Project EN070005: Southampton to London Pipeline Project
Interested Party: Nick Jarman, reference: 20022545

Attached is the Deadline 5 submission on behalf of the Neighbours and Users of Queen Elizabeth Park. This contains comments on responses to the ExA's Further Written Questions and comments on responses submitted for Deadline 4.

Deadline 5 Submission on Behalf of the Neighbours and Users of Queen Elizabeth Park

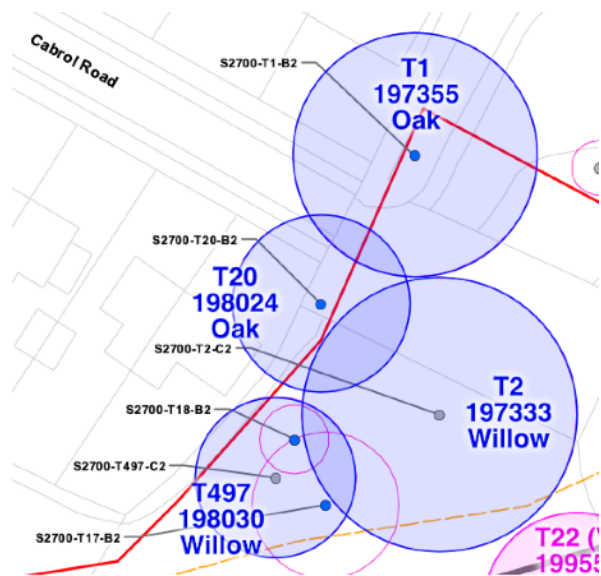
The image below shows the Notable Tree in the proposed Cabrol Road construction compound. It is listed in the Woodland Trust's ATI as number 198027.

Beech S2700-T270 (Notable)

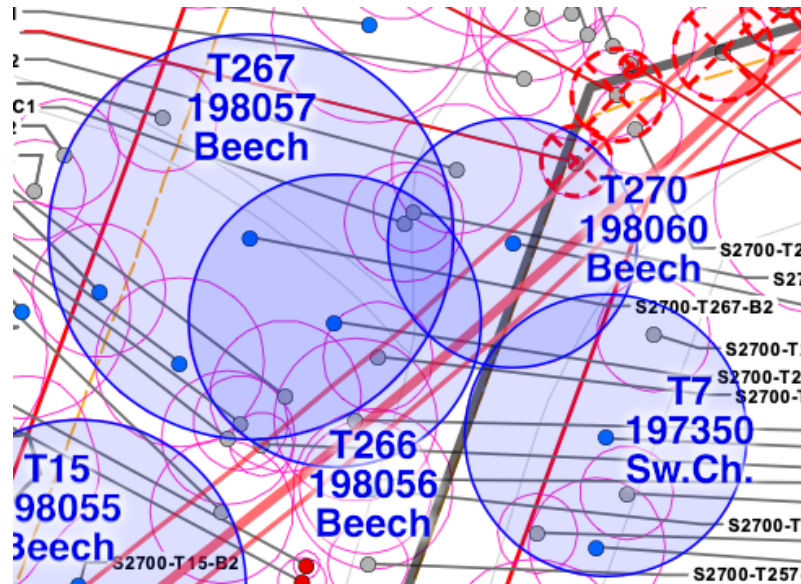
This tree is critically endangered by the trench, which passes so close to the trunk that it seems impossible that the tree can be retained. We calculate that the trench passes 0.8 metres from the centre of the trunk and severs 44% of its root area. We are deeply concerned that this tree will be removed to facilitate trenching. Whilst we understand that Esso do not currently plan to remove this tree, the DCO gives them the power to do this if needed. We would be interested to hear Esso's comments on this.

Sweet chestnut S2700-T9

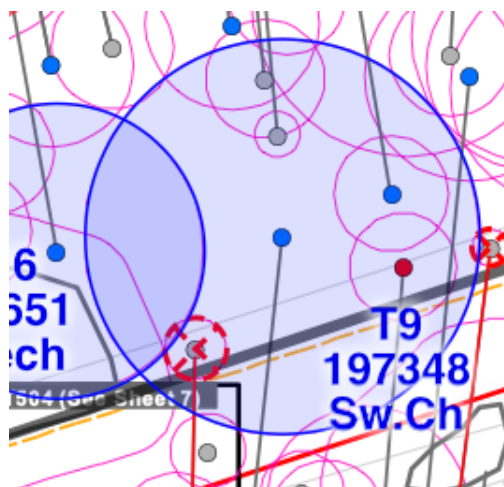
This is a particularly congested area where sweet chestnut S2700-T7 (Notable) will sustain damage to the periphery of its root zone and beech S2700-T266's (Notable) root zone is close to the trench. Damage to the latter is a possibility, depending on the exact route of the pipeline and the eventual width of the trench.

This tree has 20% of its root area severed, with the trench 6 metres away from the centre of its trunk.

Oaks S2700-T468 and S2700-T473 and beeches S2700-T475 and S2700-T480

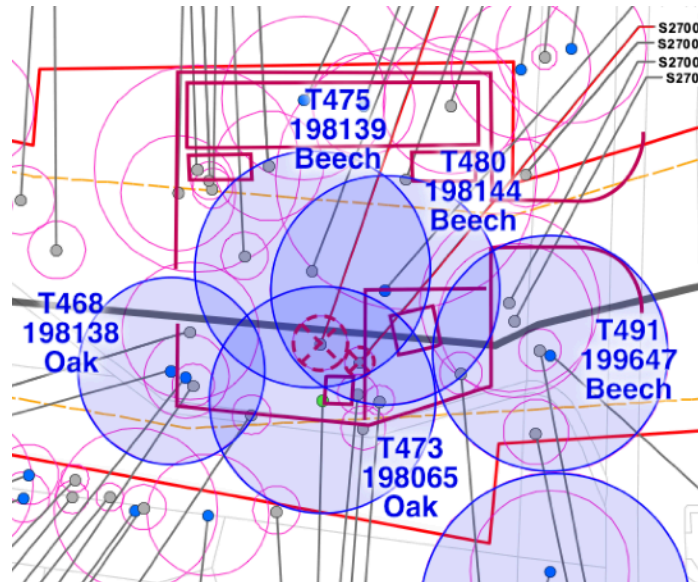
These trees are all affected by the trench, having between 16% and 27% of their root areas severed. These are all Notable Trees. The added complication for this group of trees is that they are in the auger boring compound and will be exposed to other threats described in subsequent sections.

Veteran beech S2700-T5 and sweet chestnut S2700-T4 (Notable)

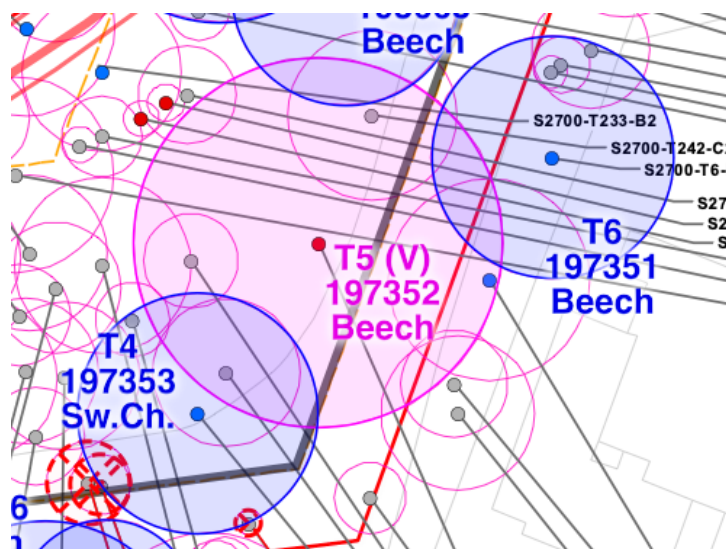
The Veteran beech has 32% of its root area severed, with the trench 4.2 metres from its trunk whilst sweet chestnut S2700-T4 (Notable) has 20% severed. Beech S2700-T6 (Notable) is just outside the trench area but at risk depending on the actual extent of its roots and the final path of the pipeline.

Scots Pine S2700-T167 (Notable)

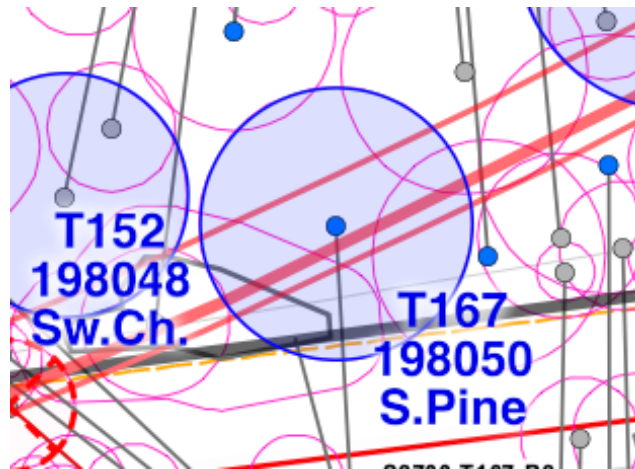
This tree has 7% of its root area severed and will be further stressed by stringing activities (see section 2.4):

Oak S2700-T35 (Notable)

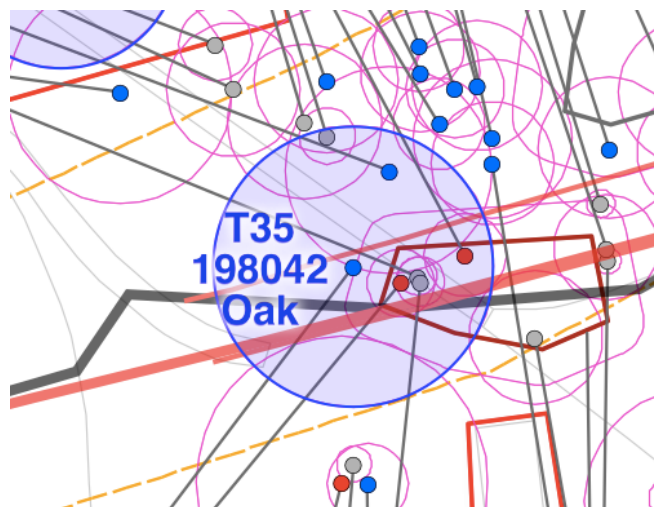
This tree is in grave danger because of the proximity of the trench to its trunk. 34% of its root are will be severed as the trench passes 2.5 metres from the centre of its trunk.

Blocker 1

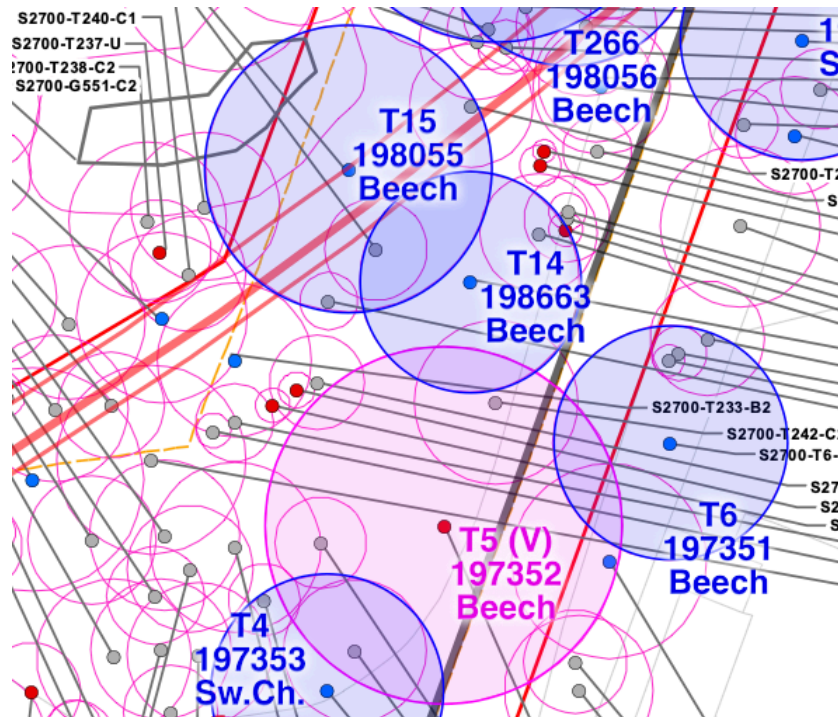
Beeches S2700-T15, S2700-T14 (both Notable) and Veteran beech S2700-T5 span the Order Limits. Beech S2700-T6 also forms part of this group.

Blocker 2

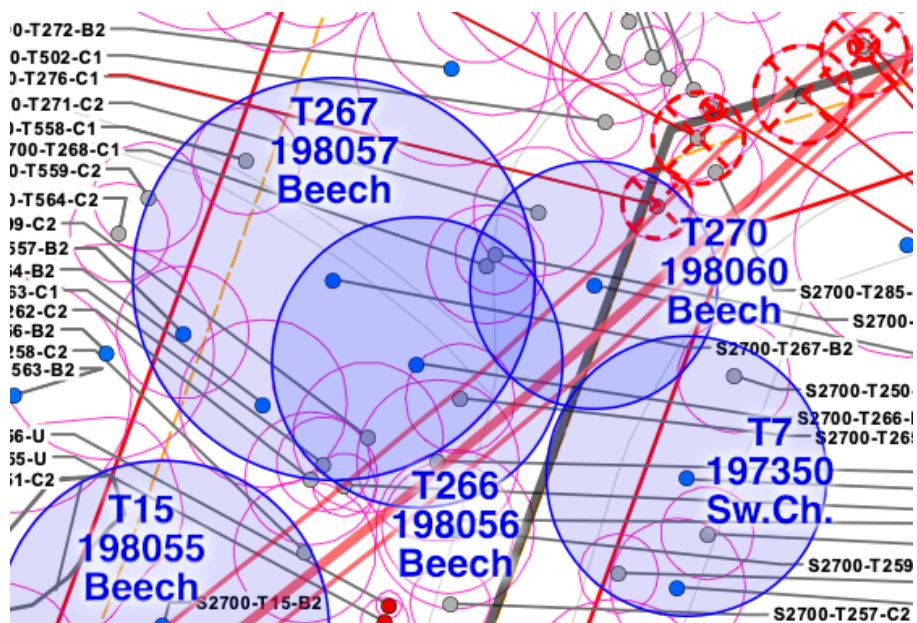
Beeches S2700-T267 and S2700-T270 (both Notable) span the Order Limits, with beech S2700-T266 (Notable) and sweet chestnut S2700-T7 (Notable) contributing additional cover.

Blocker 3

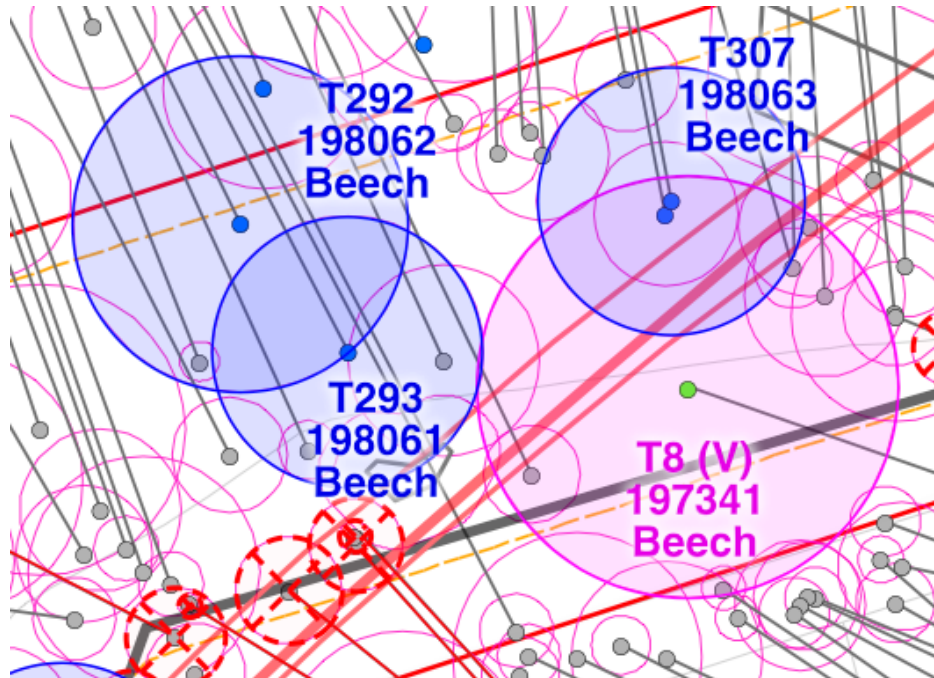
The Fairy Tree (T42/S2700-T8, Veteran) is in a group which also spans the Order Limits, with the help of beeches S2700-T293 and S2700-T292 (both Notable). Also in this group of trees is beech S2700-T307, which although it does not reach the edge of the Order Limits, does cover the Limits of Deviation.

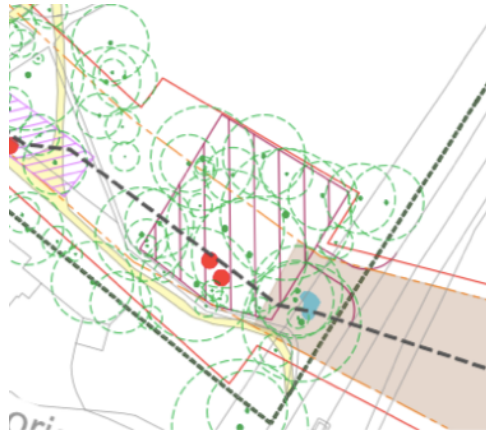
Previous drawings have shown the reception pit being located within the compound, however the 'pond' is outside the compound, as shown in the diagram below (from the QEP SSP):

The QEP Site Specific Plan states that the reception pit will be 6 x 5 metres in size and 3 metres deep. Previously the Detailed Trenchless and Targeted Open Cut Assessment⁶, section 1.23, gave the dimensions as 3m x 3m x 6m (deep). No reason is given for the change in size.

2.3.2. Completely Covered by Root Protection Areas

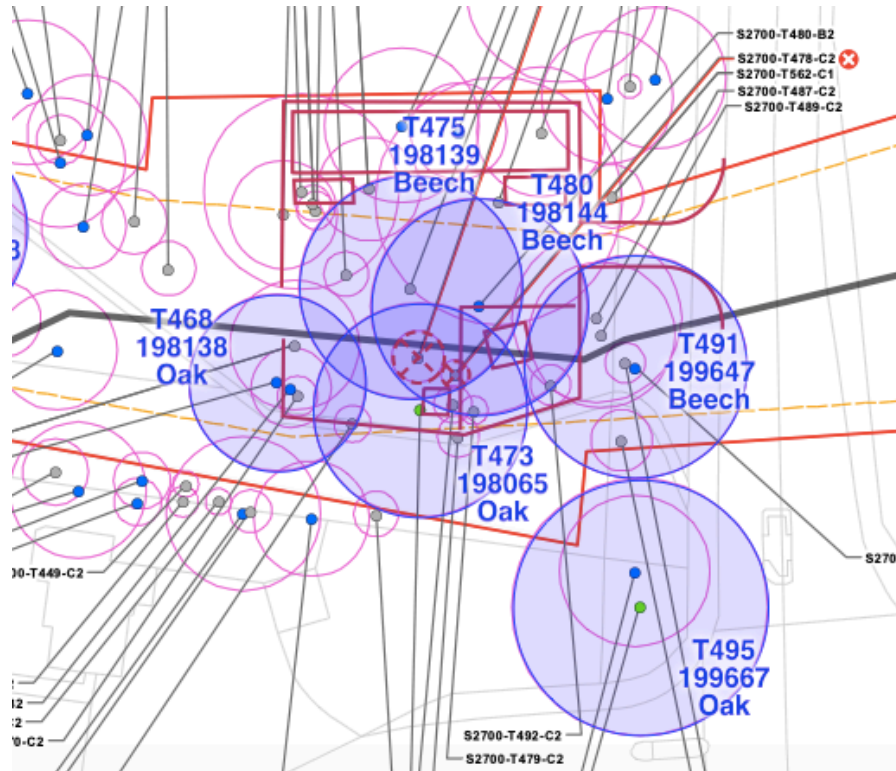
Wherever the pit is located within the compound, excavating it will cause the loss of many of the trees due to the destruction of their root areas. There may be no intention to remove the trees before work starts, but the amount of roots damaged by the work will be significant.

This is one of the densest areas of Notable Trees in the park, containing S2700-T475, S2700-T480, S2700-T468, S2700-T473 and S2700-T491 as shown above.

2.4.1. Retention of Pipe String During Pulling

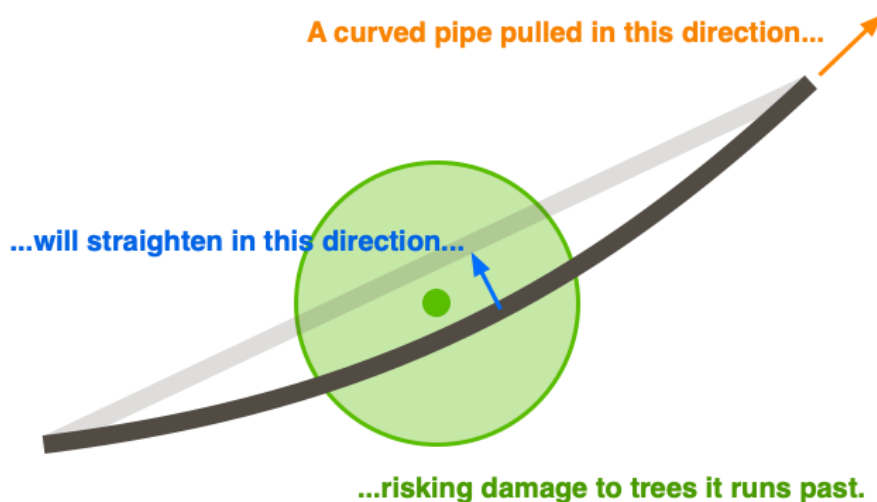
The proposed pipe string is a shallow 'S' shape. During construction of the string, it will be pulled into the park. When the string and bore are complete, the string will be pulled back into the bore.

During both pulling operations, forces exerted on the pipe string will cause the string to straighten. Any trees on the inner edge of a straightening curve are at risk of damage.

Control and containment of these straightening forces is critical where the proposed string runs close to any tree. We understand that guides and blocks will be used to counteract these forces but we are still particularly concerned about specific Notable and Veteran Trees.

2.4.2. Compaction of Root Areas

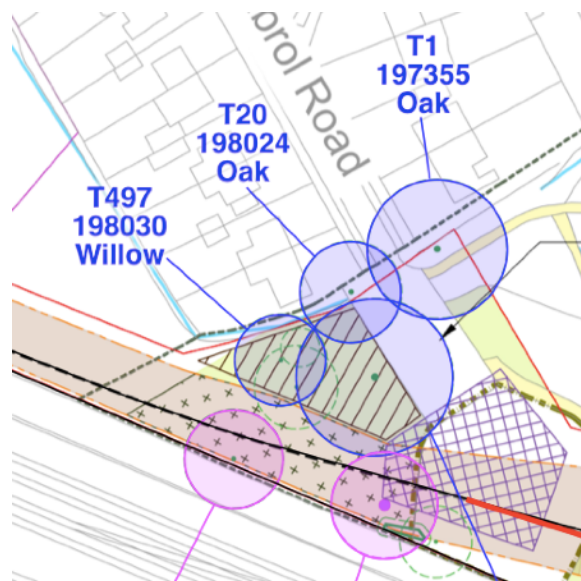
We are concerned about the impact of soil compaction within the root protection zones caused by:

1. Machinery driving over the root protection areas to pull the pipe string.
2. Machinery driving over the root protection areas to place and remove blocks and rollers.
3. Use of heavy kentledge blocks placed in the root protection area.

These activities are all inside of the area which should be fenced off for the protection of tree.

2.5.2. HDD Reception Compound

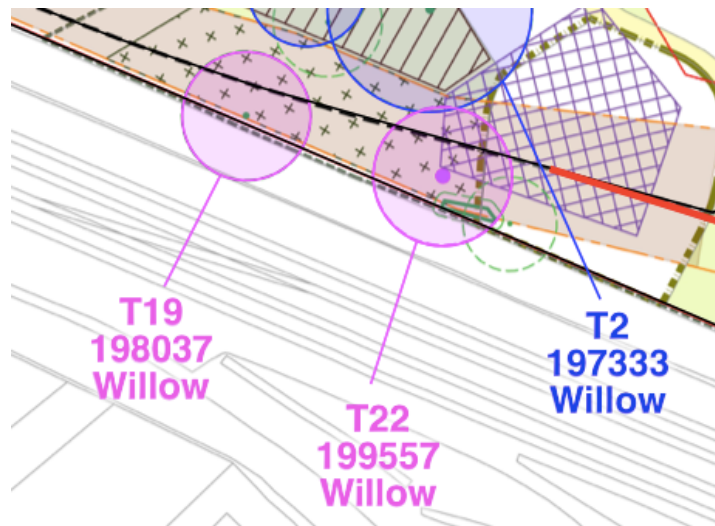
The HDD bore for TC018 passes through the root protection areas of two Veteran Trees. These are both willows, S2700-T19 and S2700-T22 (previously identified by Esso as T41).

Both trees are at risk due to the HDD bore rising up through their roots to the reception pit. T22 is most at risk, whilst the potential damage to T19 is unclear without knowing how deep the bore will be as it passes beneath the tree. A sectional diagram showing the bore and trees in this section is needed from Esso.

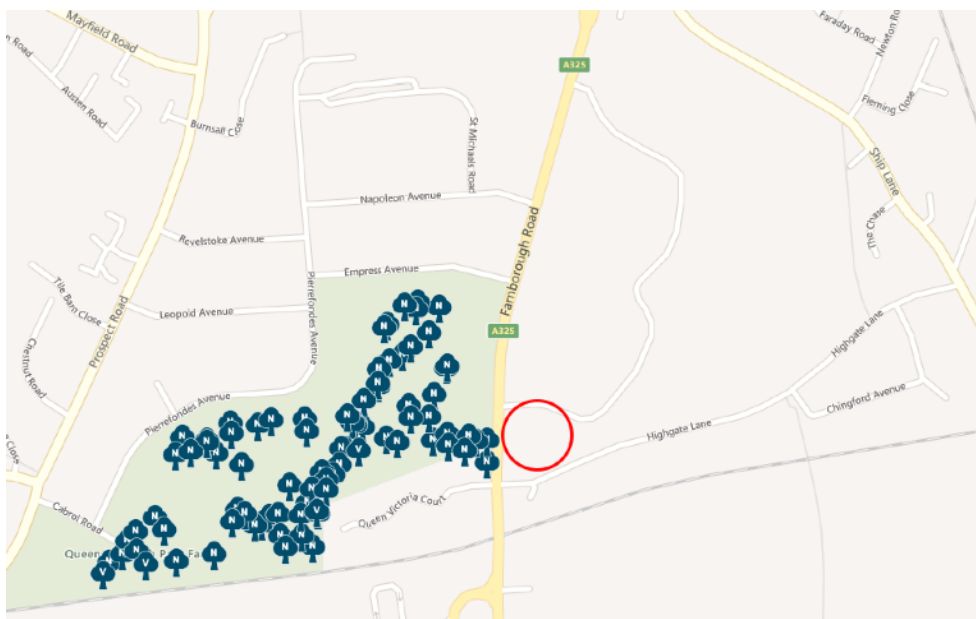
Esso's illustration 2 for point 1.3 shows that a strip of trees 5 metres wide would have to be cleared at the end of the stringing area. This is not consistent with the reassurances which Esso have given about their stringing activities in Queen Elizabeth Park, where they say they can retain all trees in the stringing area. It would be useful if Esso could explain the discrepancies between these two statements.

Of course using the 2 pull method above would avoid the boundary trees in Farnborough Hill completely.

5.2.14. Wildlife Pond

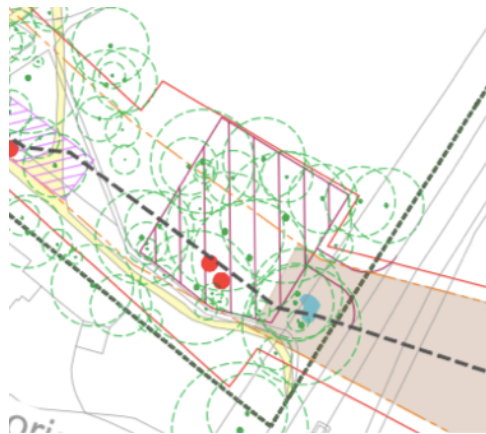
As stated in the previous section, the water body is outside the proposed compound. This is shown in Appendix B of the QEP SSP:

We would like to clarify that there is no wildlife pond on the eastern side of the park. There is a dip in the ground which collects water during heavy rain, but it is not a wildlife pond.
